PEEL Wind Farms (Yell) Ltd

Beaw Field Wind Farm

Gate Check 1

December 2015

Design Evolution
Figure 1 Gate Check 1

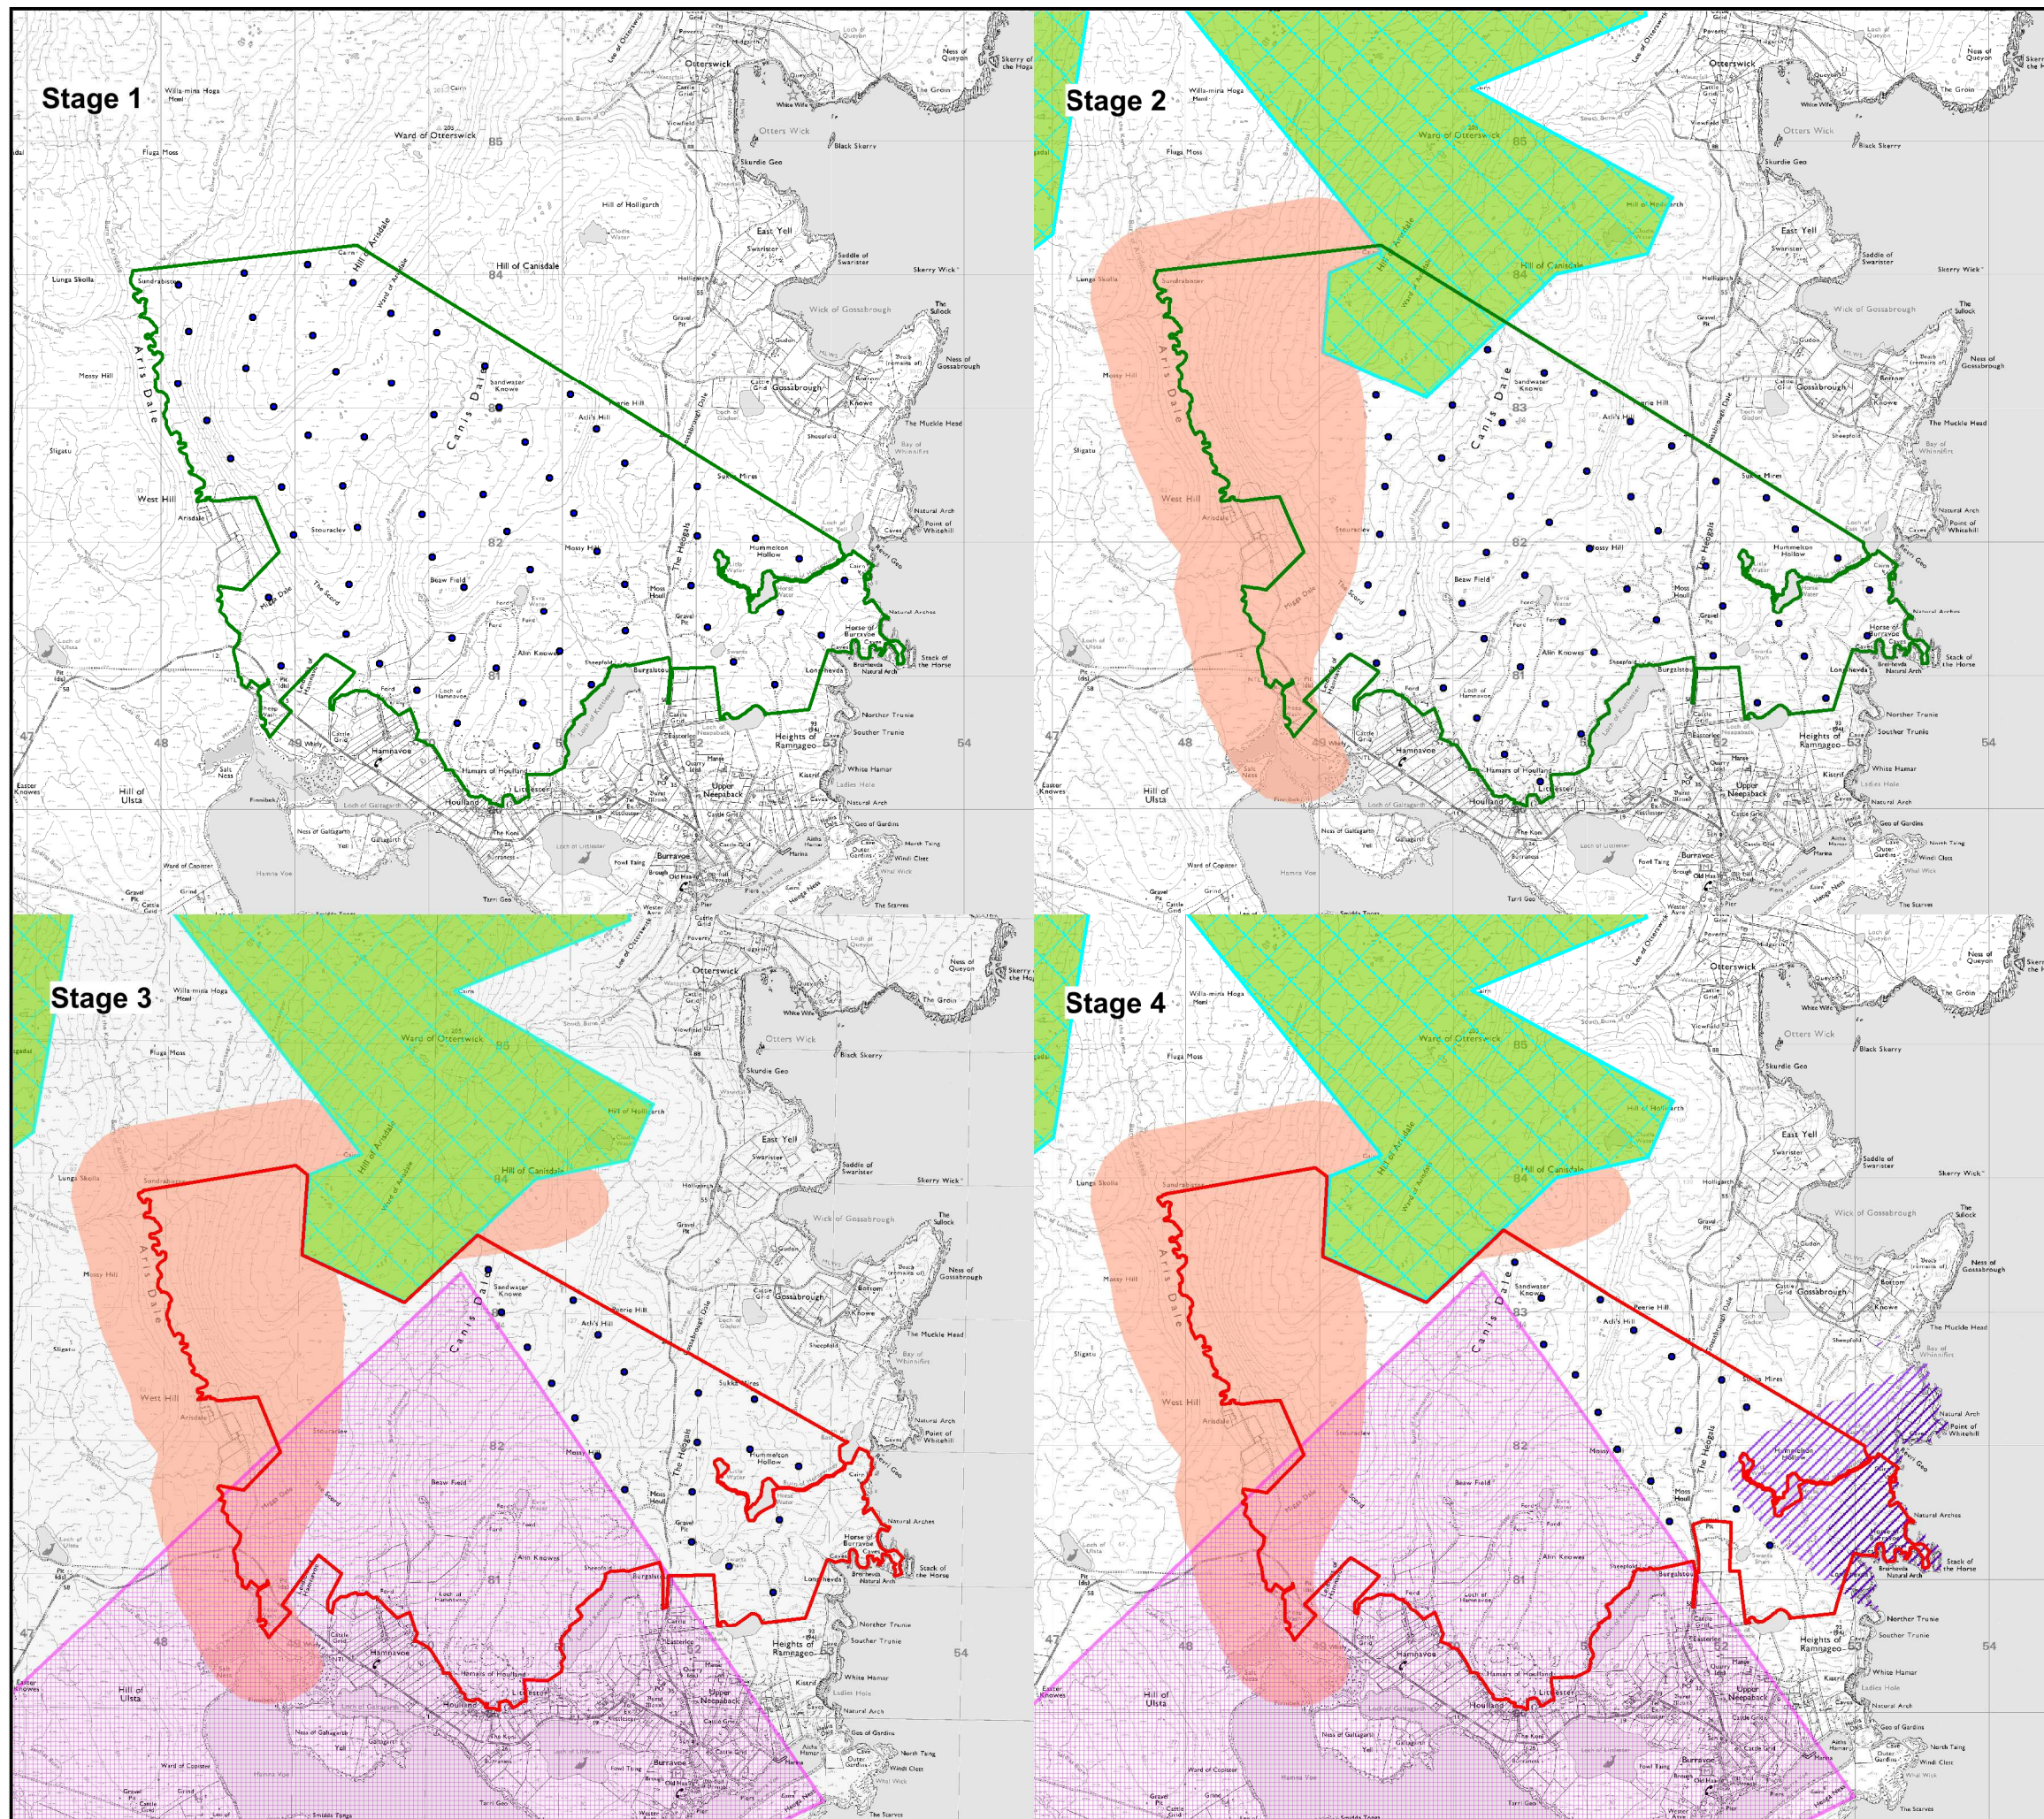
- Public consultation at scoping stage provided feedback on the turbine layout and resulted in the removal of the eastern most turbine, increasing the distance between properties in Burravoe and the wind farm.

- Four turbines have been relocated to increase the minimum distance to residential dwellings in Burravoe and Gossabrough.
- Breeding bird surveys from 2015 informed the baseline conditions with respect to the range of upland ground nesting species within the Site. These defined the presence of non-SPA breeding red-throated divers to the east of the Site (on Litla Water) and a constraint buffer for the breeding site and observed flight lines was defined around Litla Water, towards the coast. The constraint buffer resulted in the removal of 2 turbines from the scheme, these turbines were located to the east of Horse Water and Swarta Shun respectively.

- Baseline surveys for archaeology and cultural heritage identified specific features within the Site which have been avoided in design freeze.
- A 1500m protection buffer has been applied to the Gossabrough Brock Scheduled Ancient Monument to preserve its setting.

- A minimum distance equal to the tip blade height has been defined for the turbines adjacent to the B9081.
- Protection buffers have been identified to minimise potential impacts on blanket bog habitat and GWDTE, although it has not been possible to avoid the disturbance of unmodified blanket bog habitat during the construction phase.

- In consultation with BT regarding the final design layout, a microwave link that had not been revealed at scoping stage was identified, as crossing the Site and accommodated in the design freeze layout.

Design freeze was based on the review of turbine layouts that took account of technical and environmental constraints identified through the process of desk based and field surveys (see Figure 1: Stage 4). At design freeze, the layout of the wind farm comprises 17 turbines with a maximum height to tip of 145m. The location and dimensions of the temporary construction compound, substation and borrow pits were progressed on the basis of the turbine layout at design freeze. The concept engineering designs for these elements of wind farm construction has been used to inform the EIA process (see Figure 2).

Design Freeze Wind Farm Turbine Layout

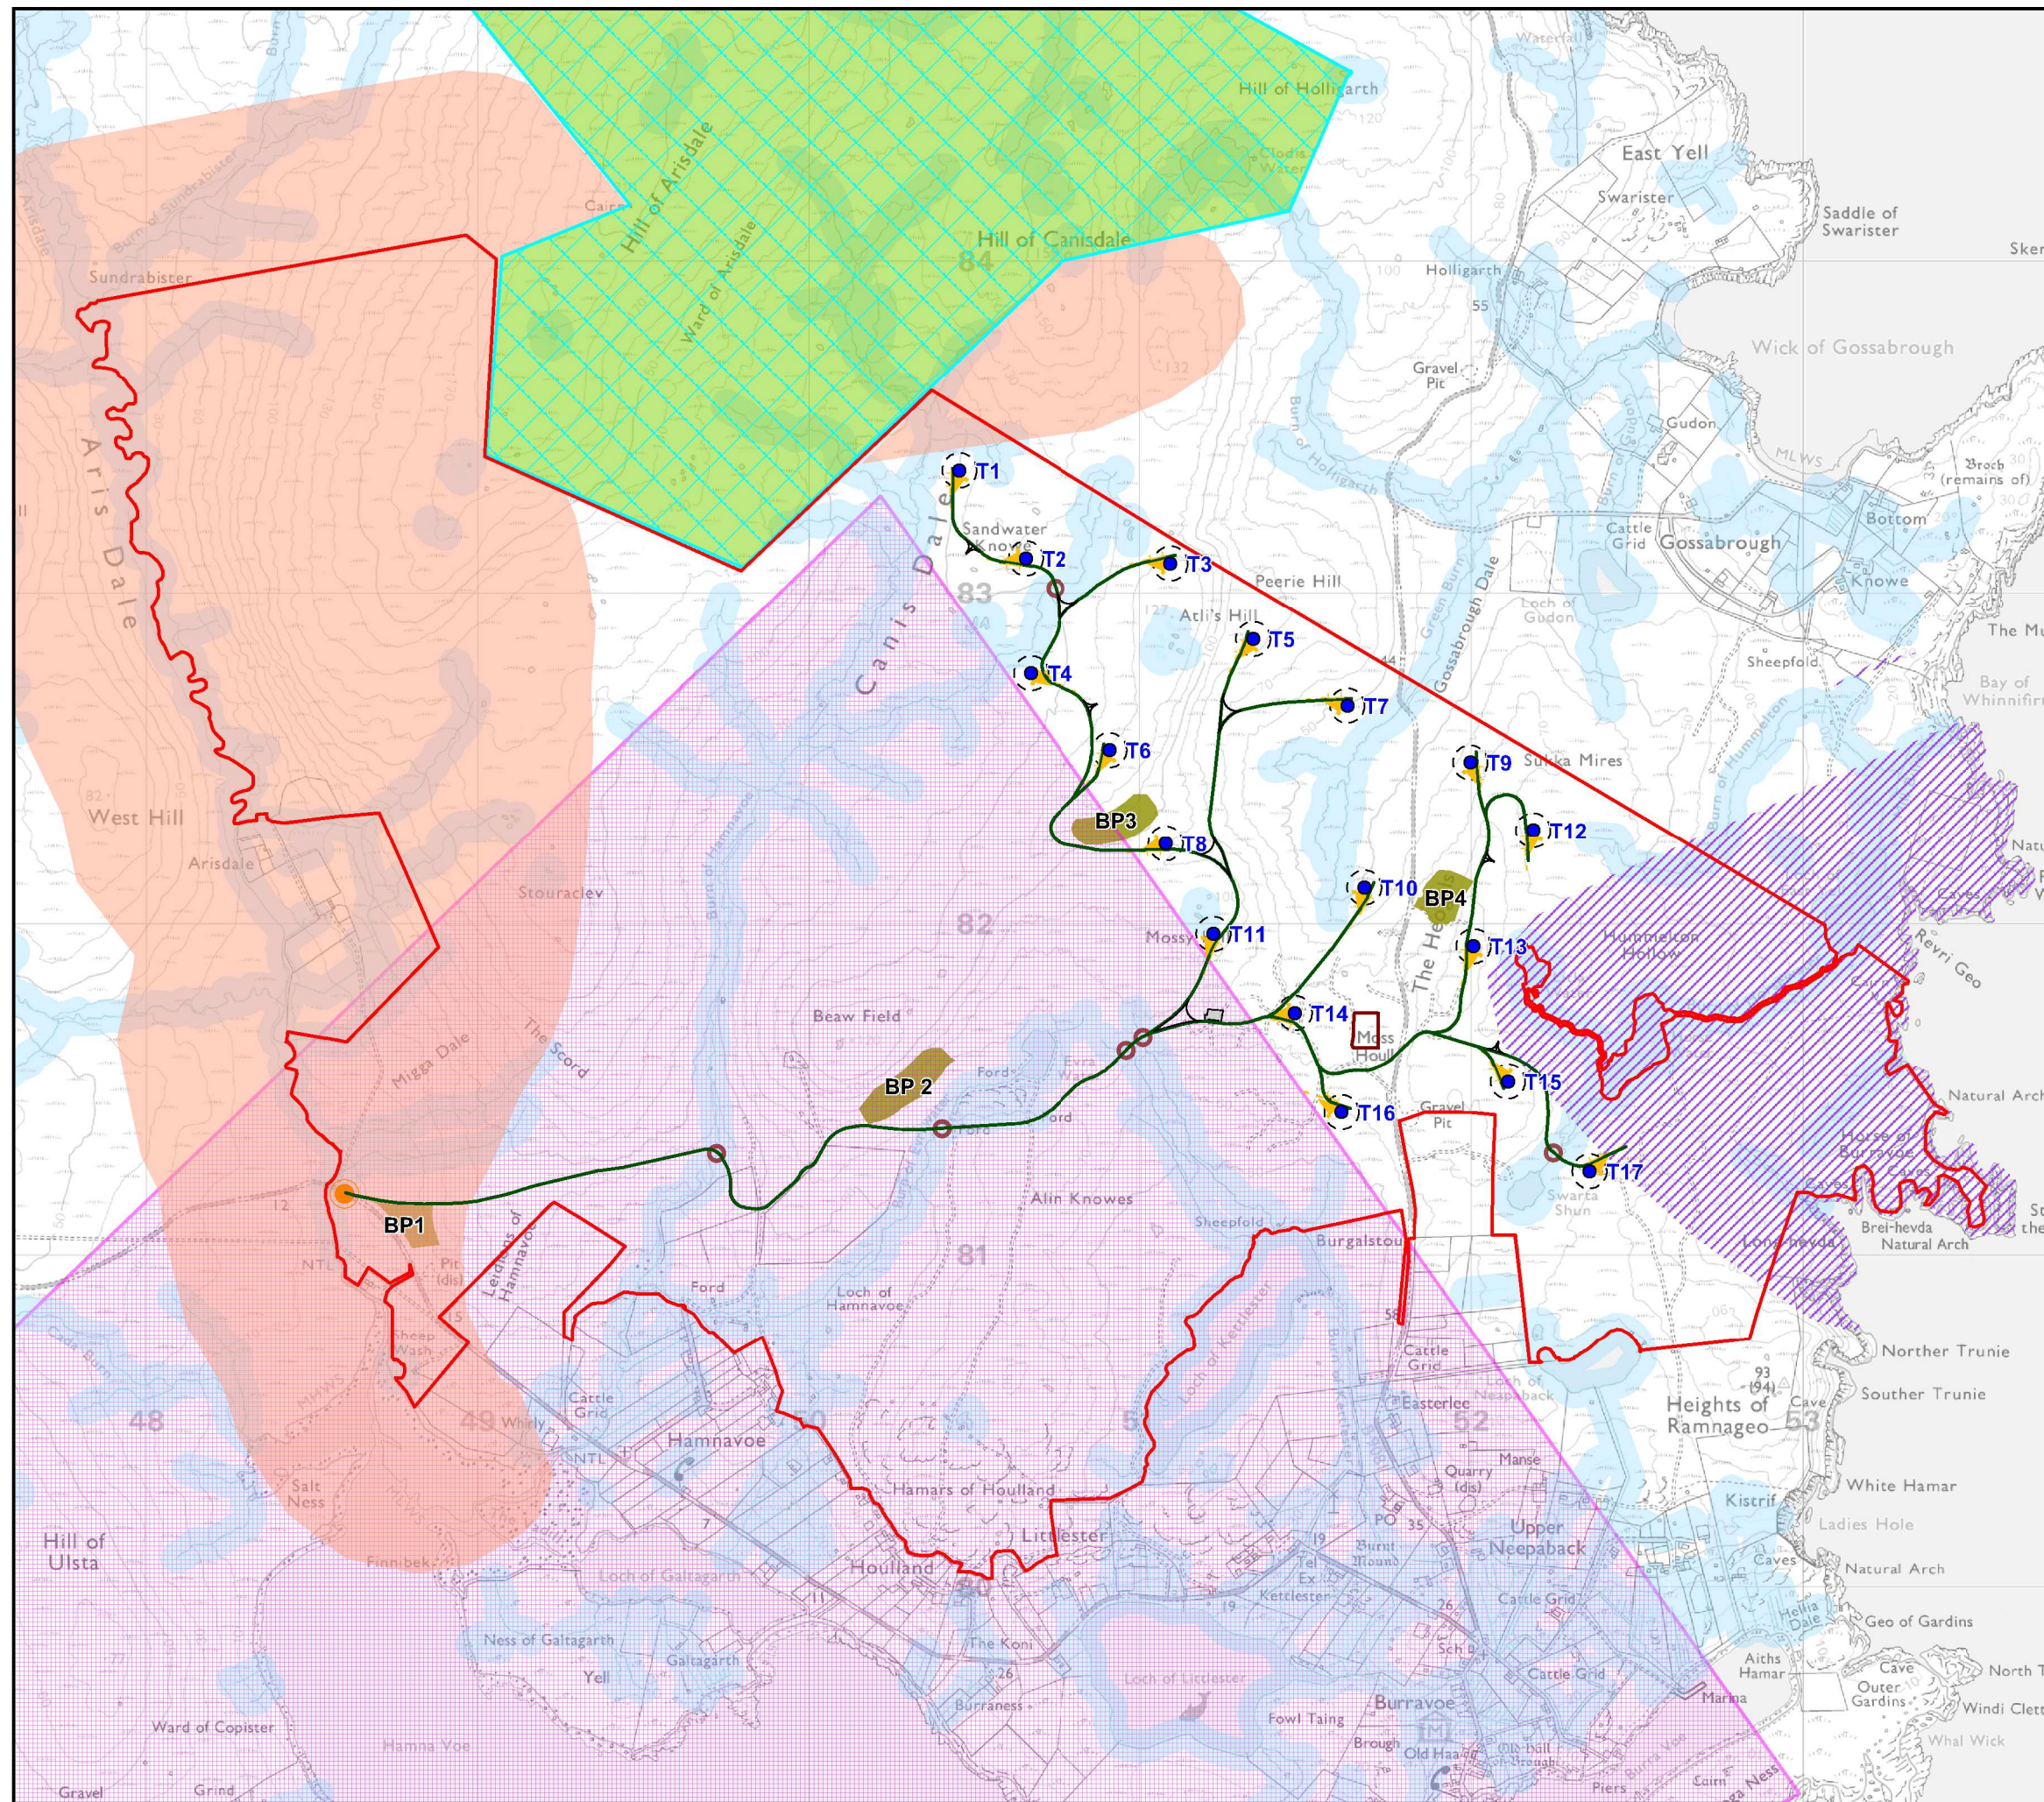
Topic	Consultee	Section	Comments	Comment / Action Taken
Otterwick and Graveland SPA	Scottish Wildlife Trust	Designated Sites and their Features	Turbines 1, 3 and 12 are close to the SPA boundary and in order to undertake appropriate assessment on divers, extensive diver surveys should be undertaken following SNH best practice guidance, to identify regular flight lines and accurately assess potential impacts.	The ES chapter will include sufficient information to allow the competent authority undertake on HRA.
	7 th May 2015		The impact on Yell Sound Coast, designated as a SAC and SSSI needs to be carefully considered in the survey work and any proposed mitigation, especially in terms of road-upgrading work (outside Application boundary) and runoff from construction.	SNH do not identify adverse impacts on SAC. Opportunities to enhance features of SAC through mitigation will be addressed in ES.
